ADDENDUM NO. 03

Northland Corridor Redevelopment Project Phase 4
631 Northland Ave.
Buffalo, NY 14211

Project No. 432607

Project Northland Corridor Redevelopment Phase 4 (BUDC) Addendum No. 3
631 Northland Avenue, Buffalo, NY Contract -
Wendel Project No. 432607 Date 10/22/25

APPROXIMATE ASBESTOS ABATEMENT QUANTITIES APPLICABLE TO HM-102 (FOR BIDDING ONLY)

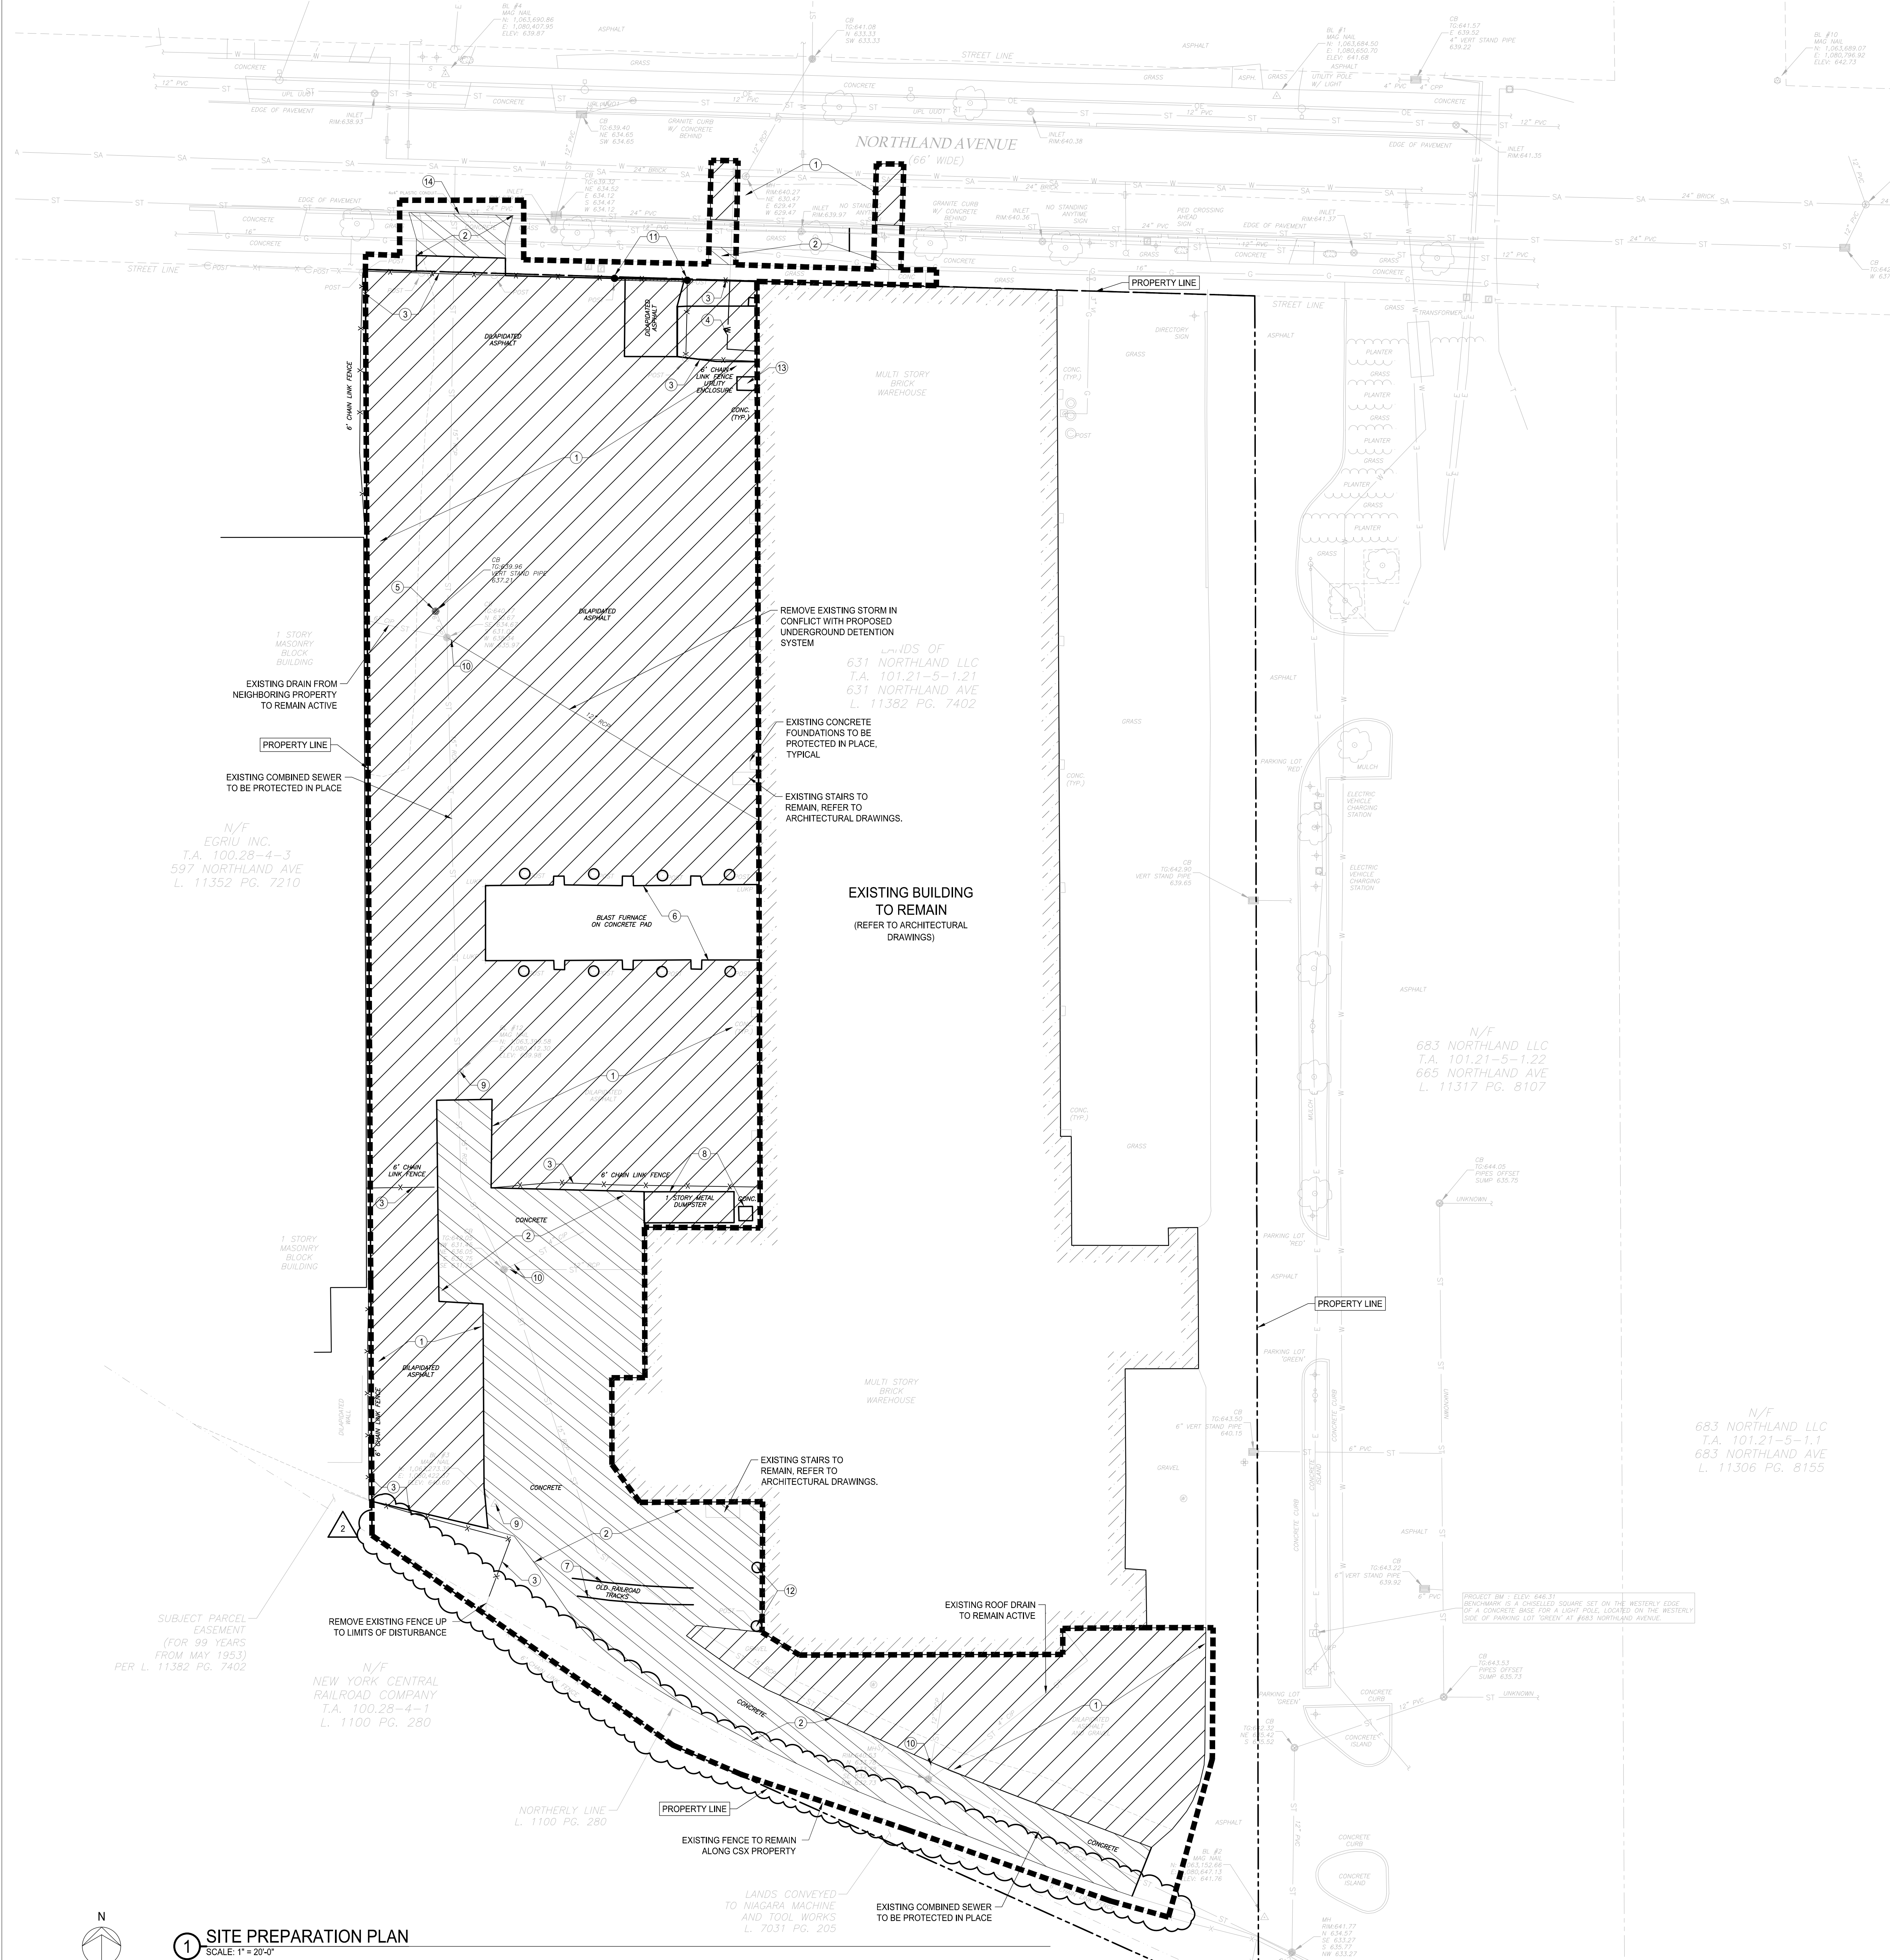
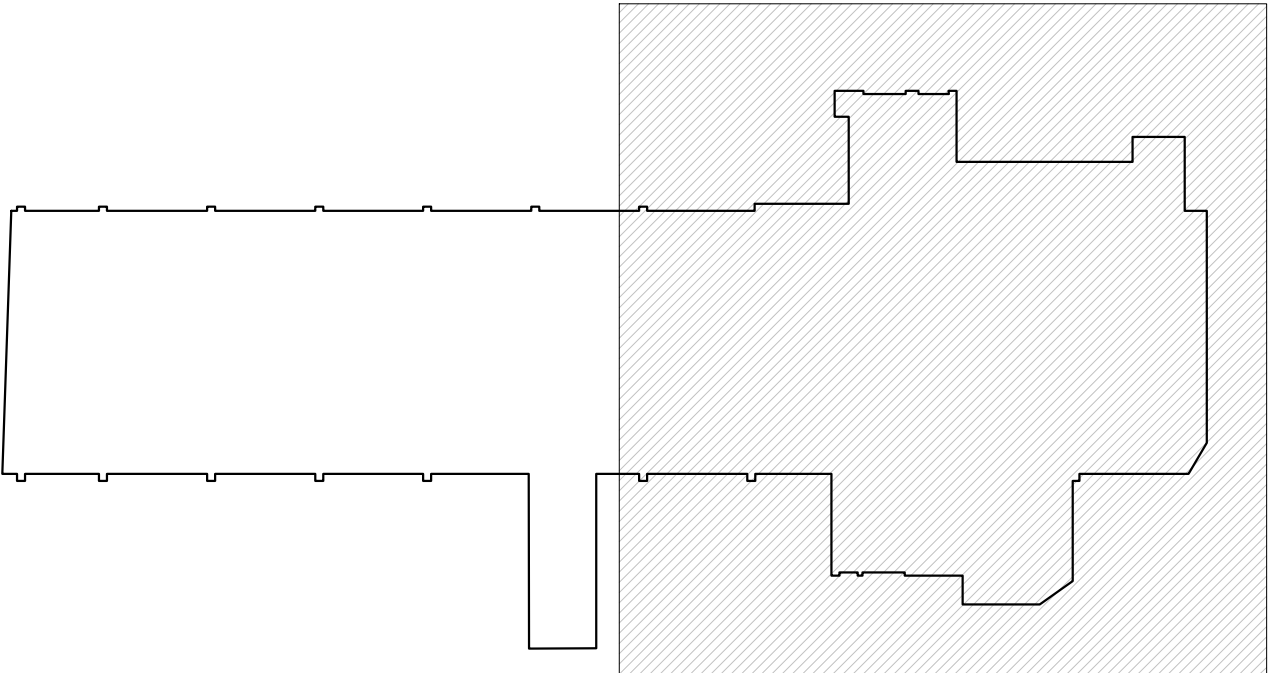
CLARIFICATION: Hazardous materials incidental disturbance areas and linear feet have been clarified on the revised referenced drawings issued as part of this addendum.

QUESTION: The HM drawing quantities show door caulk, electrical wiring, window caulk, window glazing, and mudded joint fittings in square footage. What was the conversion rate that was used to convert the quantities from linear footage to square footage as these items are usually shown as linear footage. For caulking it is normally 48 linear feet is equal to 1 square foot. For mudded fitting it is usually one fitting is equal to one linear foot what rate was used to convert it to square footage ?

ANSWER: In accordance with EPA Guidance RE&LS is limited to quantifying materials in linear feet to thermal systems insulation (piping, elbows, fittings) which do not exceed 12" diameter. As such, we have amended the quantities to show piping (MJP) as Linear Feet. The conversion rate used for MJP was equal to one fitting / elbow = one LF. For caulks / glazing associated with the windows, due to the number of layers present we accounted for one SF of material per window unit. For doors, due to multiple layers, we accounted for one SF per door. For electrical wiring insulation, we measured the assumed distance and took the width of the insulation to determine the quantity provided. Please refer to revised HM100 – 102 in this addendum.

C103

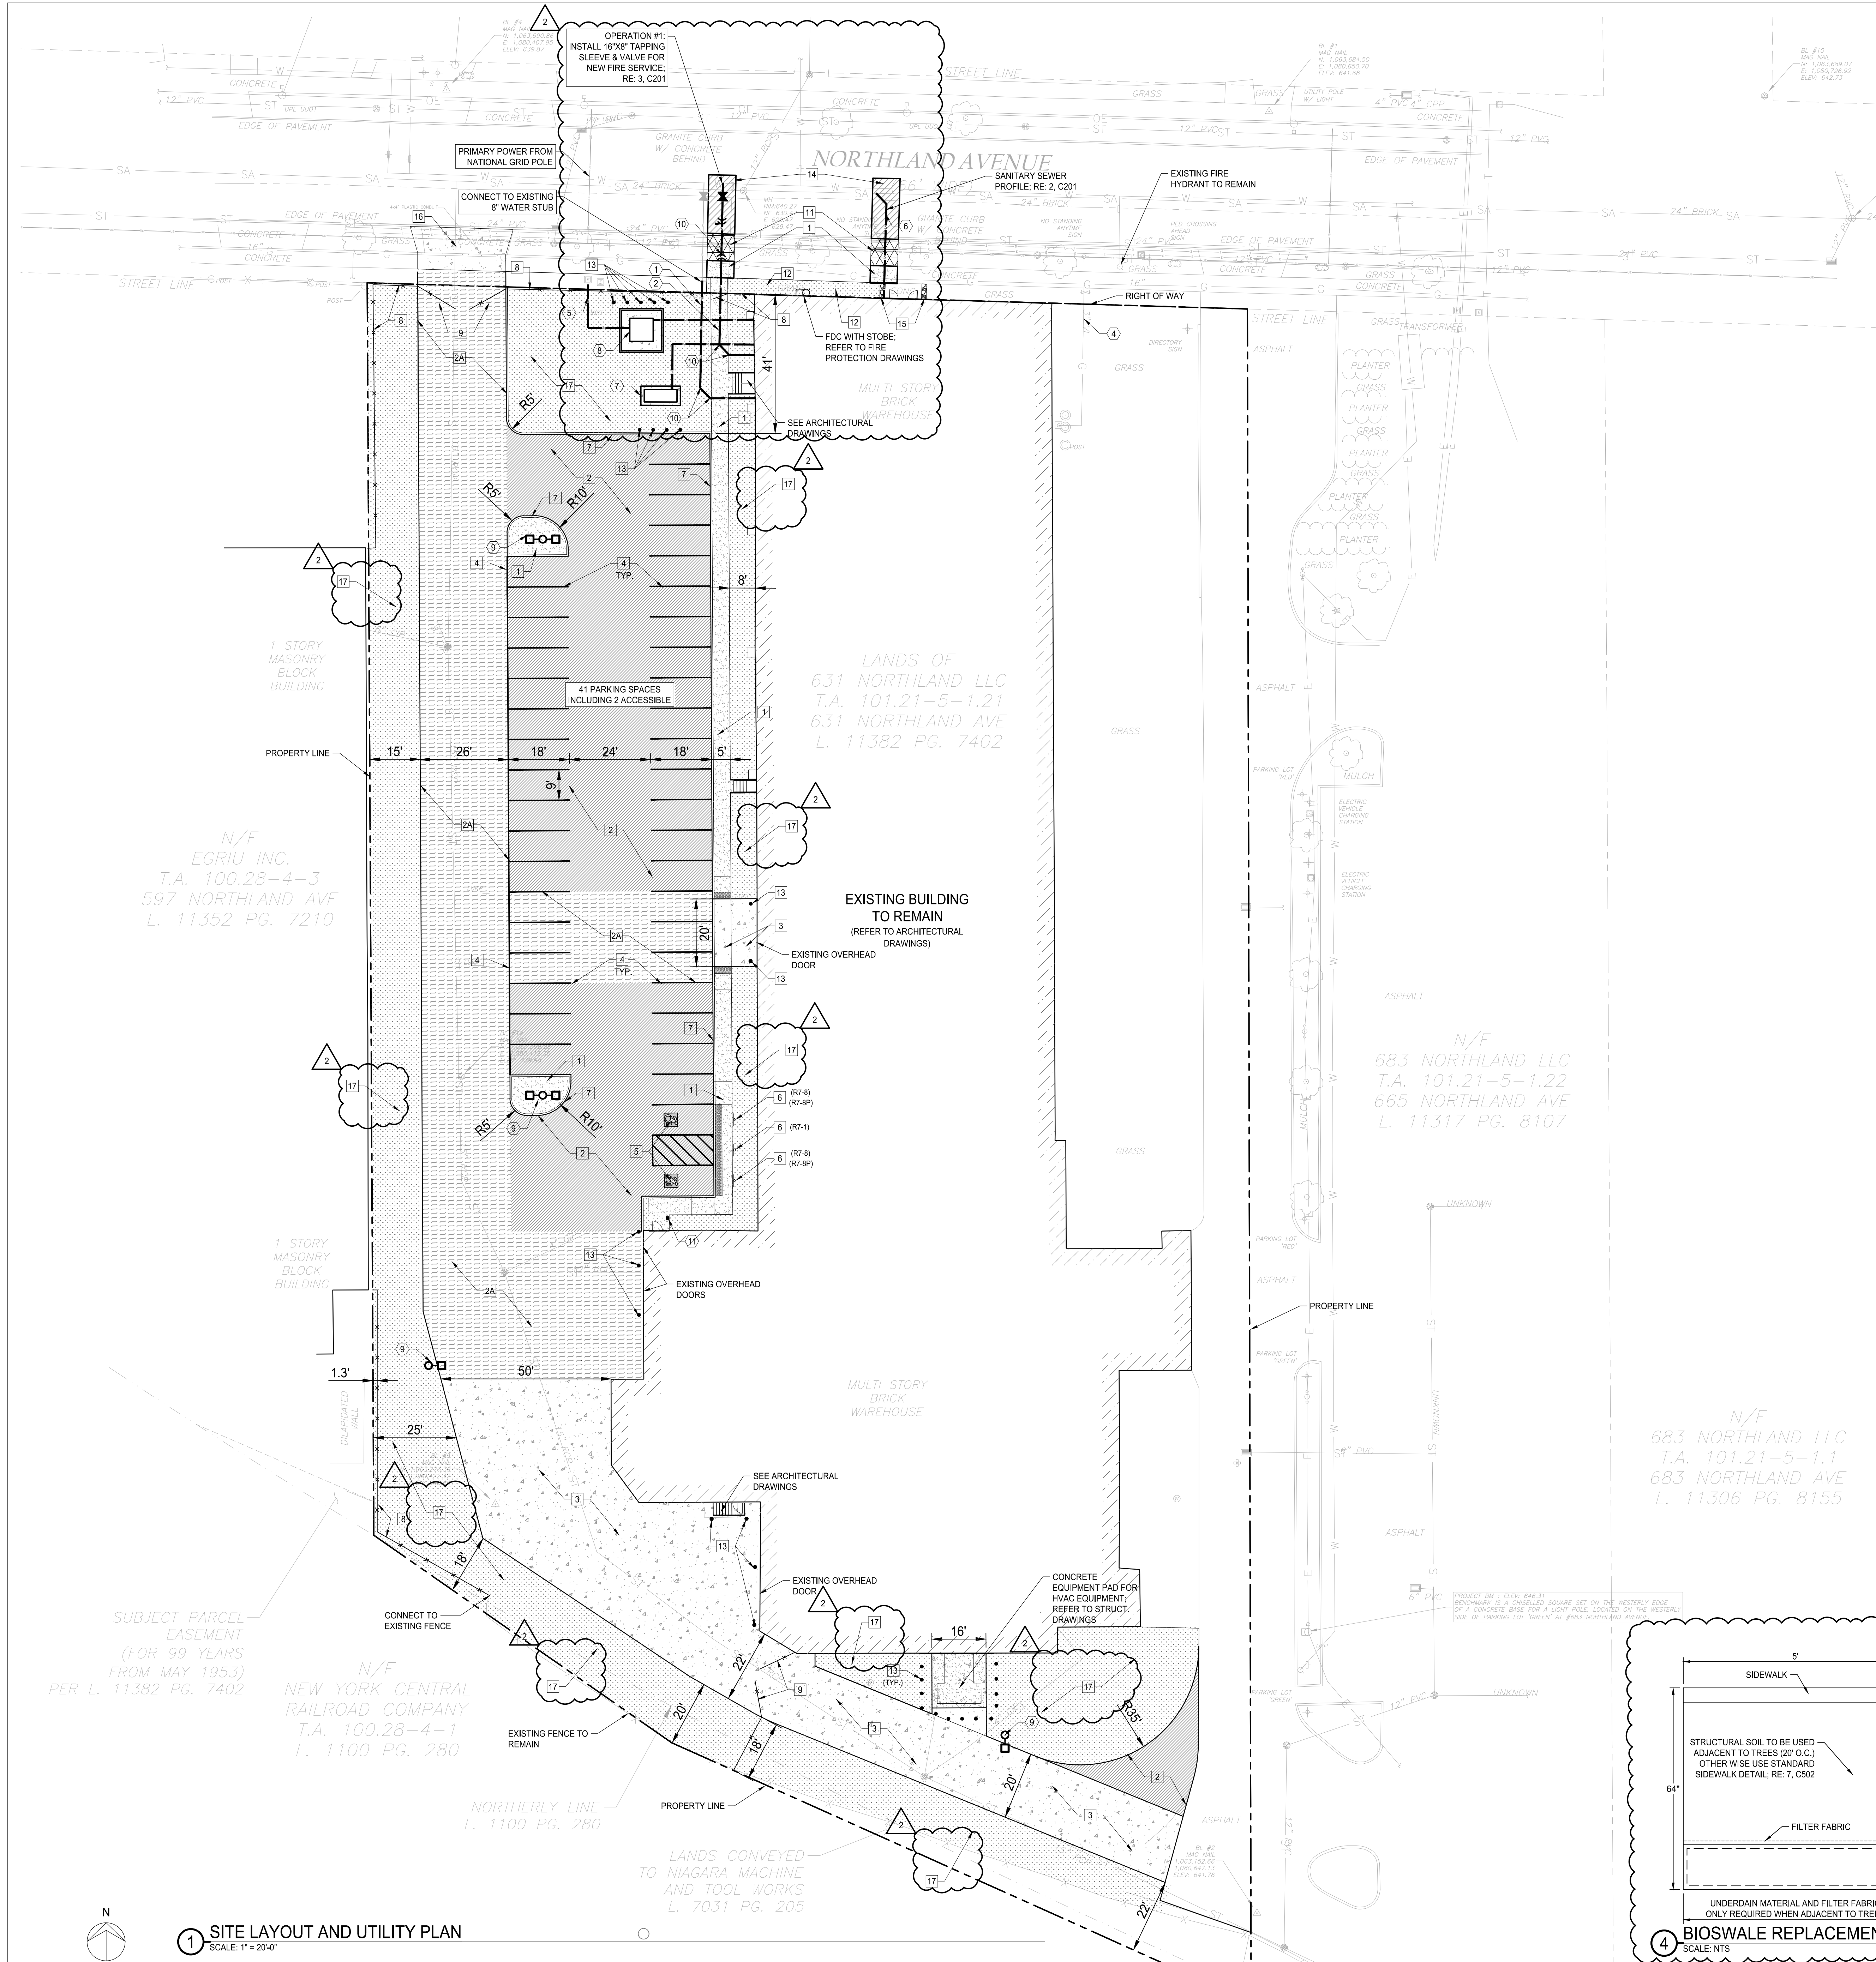
DELETE: Civil drawings C102, C103, C201, C301, C302, C503, C504.

CLARIFICATION: Revisions in the above referenced sheets accommodate environmental requirements and provide clarification to utilities, drainage, and grading.

ADD: Revised civil drawings C102, C103, C201, C301, C302, C503, C504 issued as part of this addendum.
